Department of Permitting & Inspections

TO: Development Review Board
FROM: Scott Gustin
DATE: November 15, 2022
RE: ZAP-22-4; 89 Chestnut Terrace

Re: BHS | BTC Reconstruction – Project Narrative

Burlington School District (“BSD”) is proposing to reconstruct the Burlington High School/Burlington Technical Center (“BHS/BTC”) property at 52 Institute Road. The reconstruction project will consist of remediation and demolition of all but one of the existing buildings and construction of a new BHS/BTC building. This narrative provides a description of the project and addresses several key design aspects and regulatory requirements as outlined in the Burlington Comprehensive Development Ordinance (“CDO”).

SHEET NO: C2.5

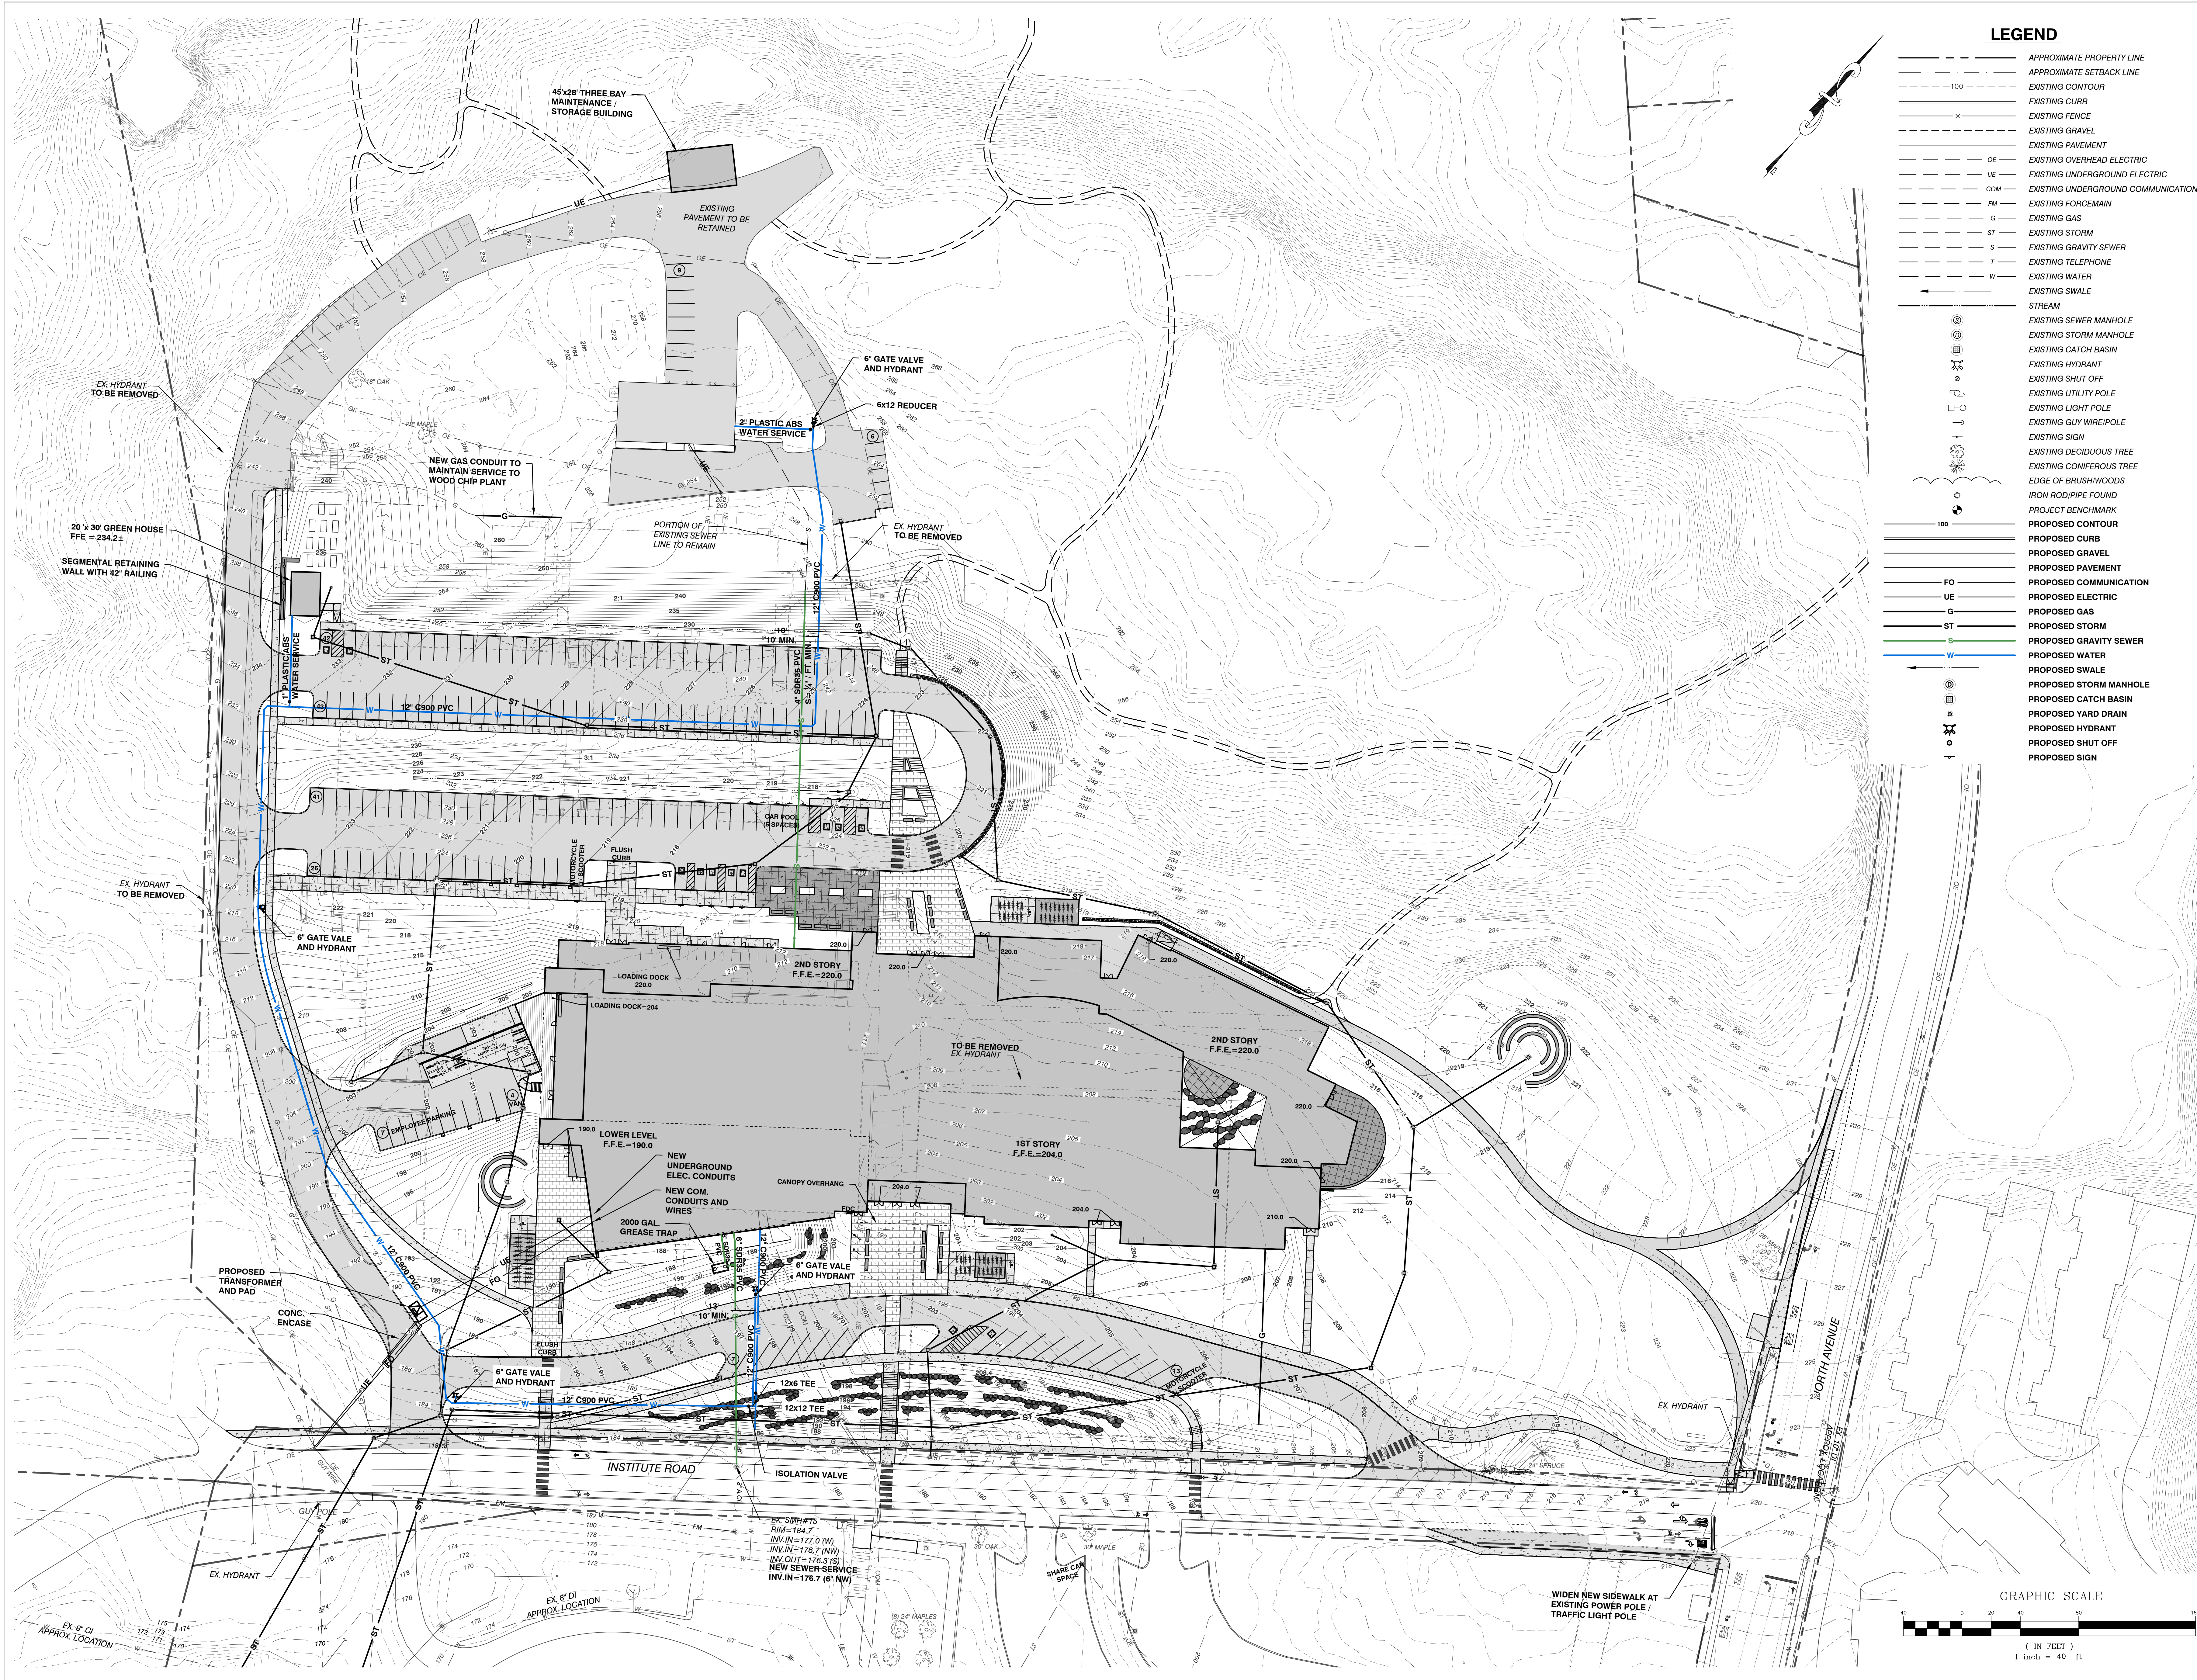
Any required revisions to the submitted plan must be forwarded to DPI and Water Resources unless specific conditions are imposed by the DRB. A revised plan was received 11.4.2022; see Plan C2.2.
